RICHMOND METROPOLITAN TRANSPORTATION AUTHORITY

CONTRACT NO. MR – 2017

MISCELLANEOUS REPAIRS

ADDENDUM NO. 1

RICHMOND METROPOLITAN TRANSPORTATION AUTHORITY			
BRIDGE 67 PIER 12W FLOORBEAM 16			
HNTB		HNTB CORPORATION ARCHITECTS ENGINEERS & PLANNERS ARLINGTON, VIRGINIA	
SCALE AS NOTED	DATE FEBRUARY 2017	SHEET 4 OF 5	
PLAN NO. A	PROJECT MR 2017	FILE NO.	SHEET NO. SP-I-4

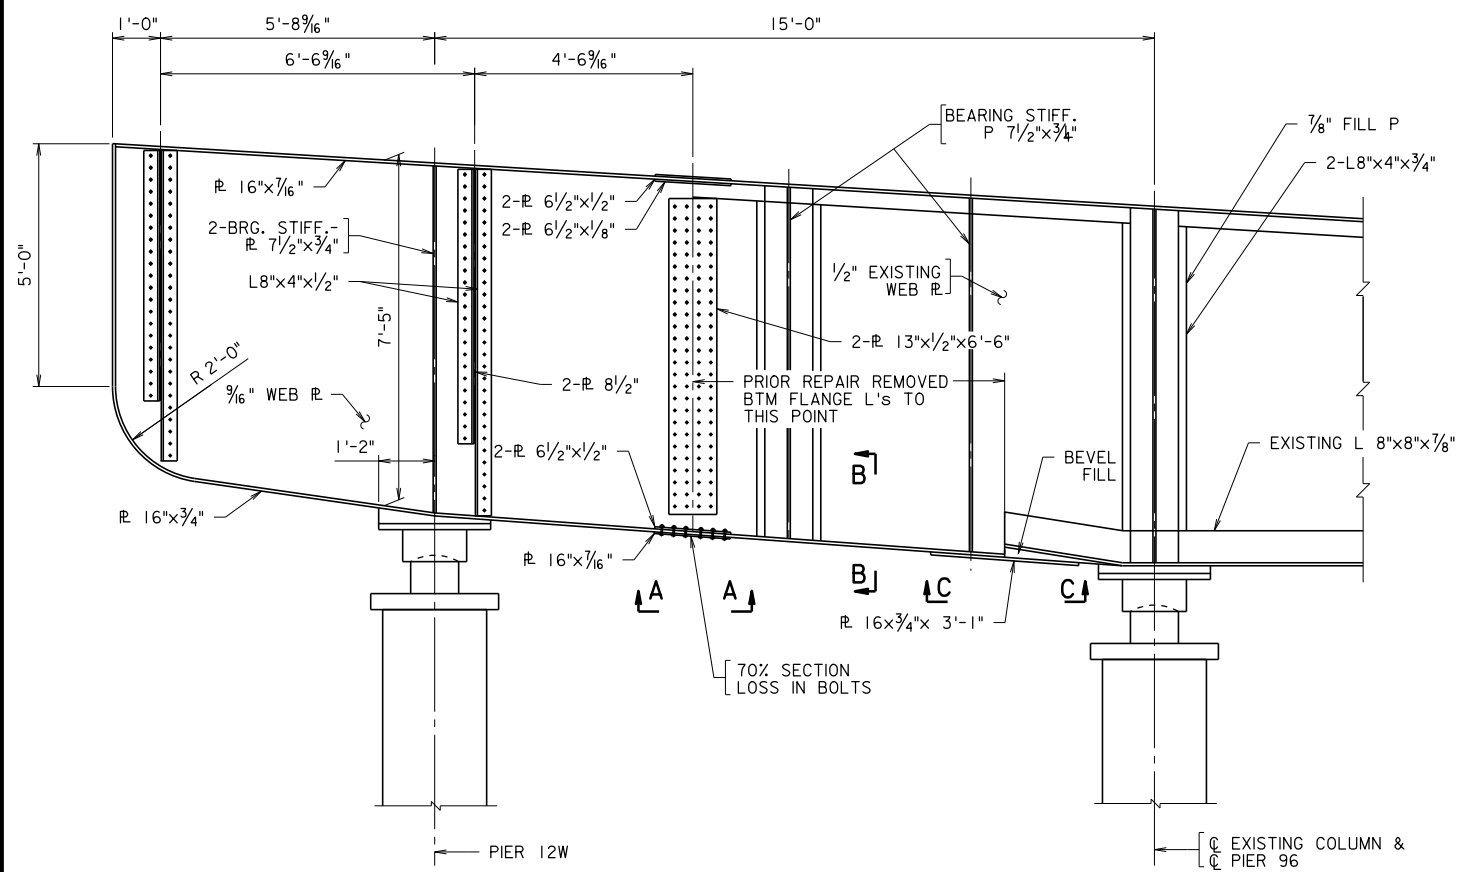
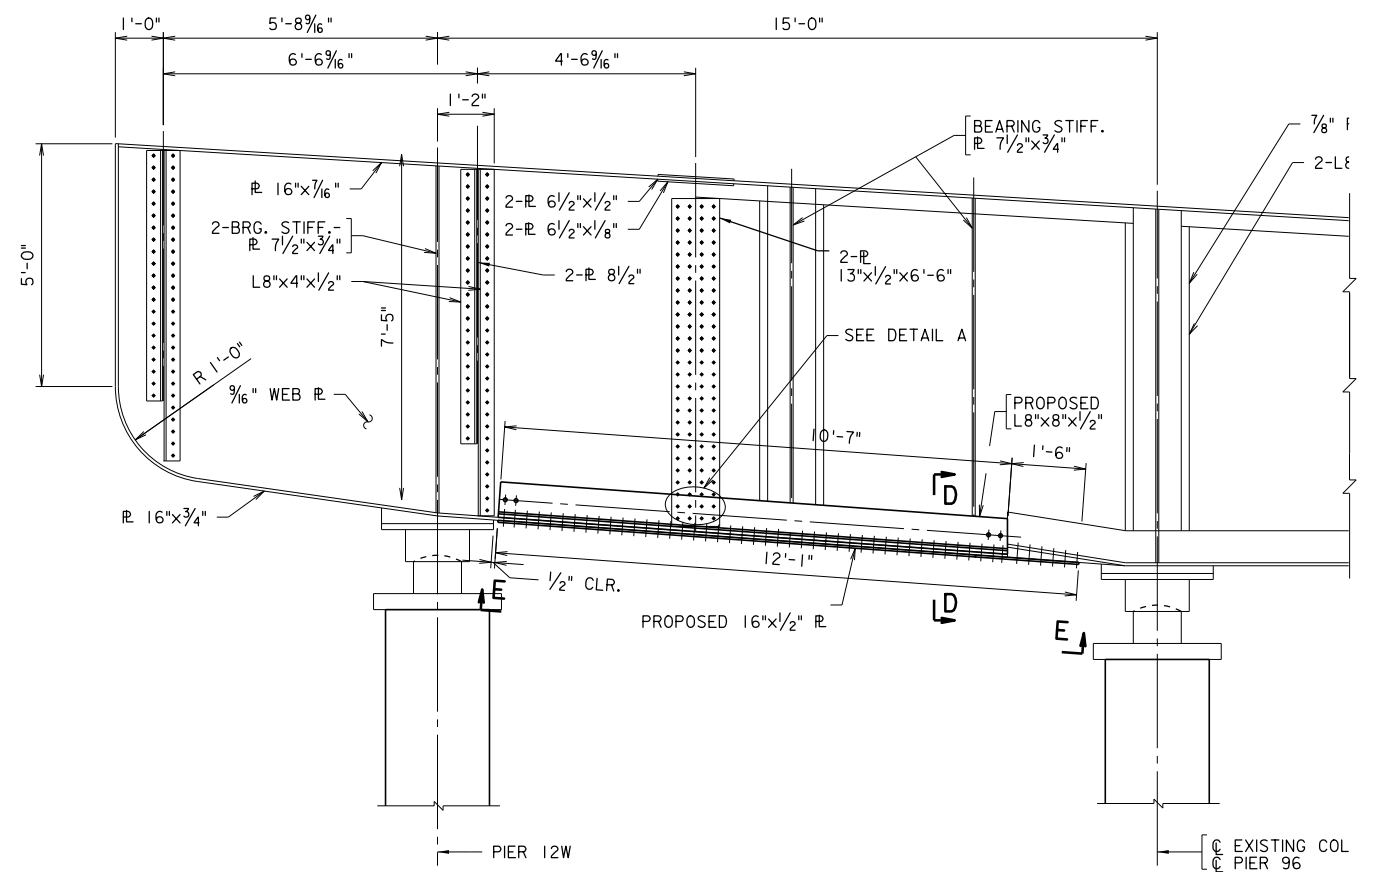
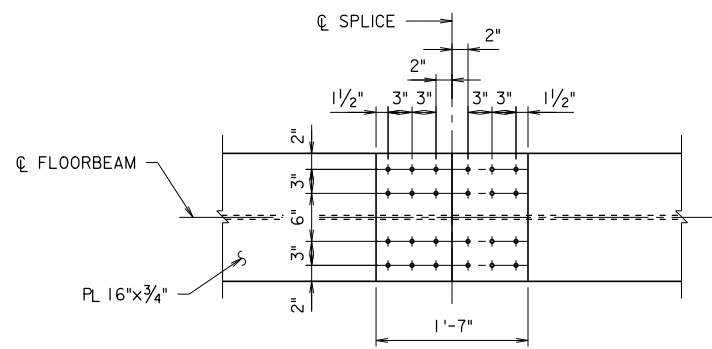
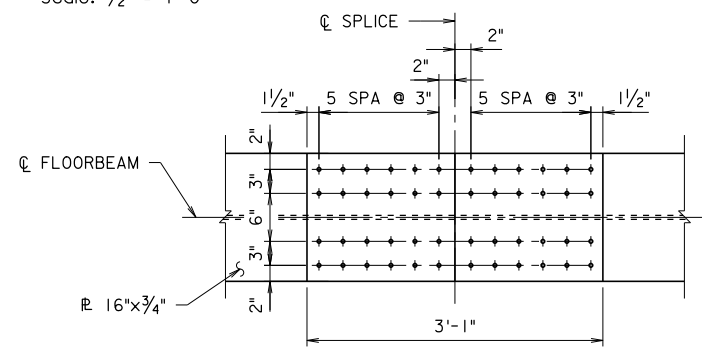
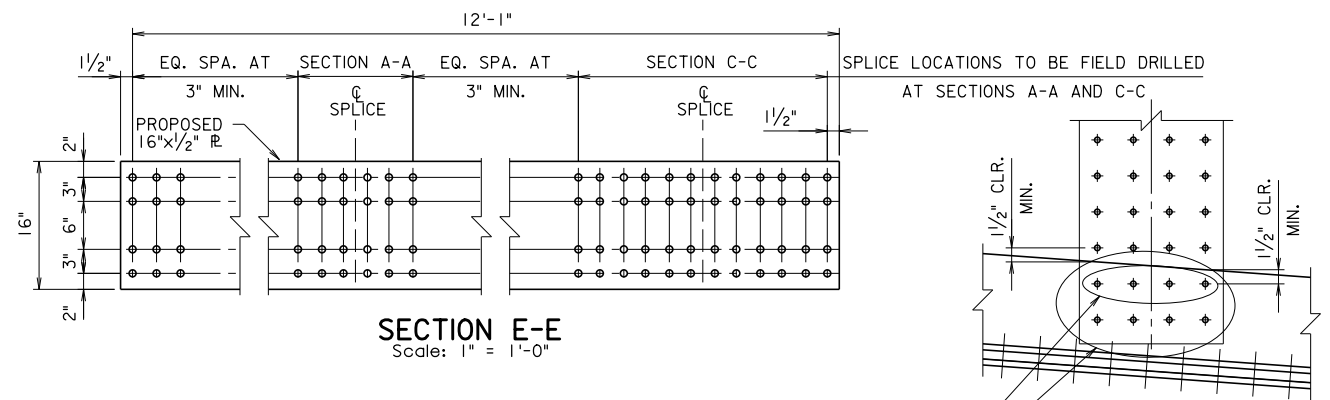
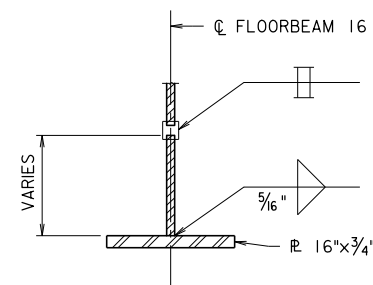
1. All Bidders are directed to replace the Bridge Repair Plan Sheets: SP-I-4, SP-I-5, SP-I-6 from the Bid Documents with Addendum No. 1 Bridge Repair Plan Sheets: SP-I-4, SP-I-5, SP-I-6.
2. This addendum has been issued to revise various details, sections, quantities, notes and suggested sequence of construction on each Plan Sheet.

1. Remove traffic from bridge.
2. Trim web splice plate to accommodate proposed angles.
3. Remove deteriorated section of stiffeners or at a minimum enough section to accommodate the proposed angles, whichever controls. Removal shall consist of air carbon arc gouging and then grinding smooth. Engineer shall perform visual inspection of areas and dye pen test for cracks of any suspected areas.

4. Remove bottom flange splice plates.
5. Clean and paint all rusted areas in repair limits.
6. Field drill holes through strengthening angle, plate and fill plates as identified for field drilling on sheet SP-I-5. Place 16"x1/2" strengthening plate. Install connecting bolts on east side of web. Locate angle and fill plates (if required) and complete connection.

7. Insert web bolts after all angles connected to flanges.
8. Weld proposed section of stiffener to existing web and stiffener.
9. Paint all new repair areas.
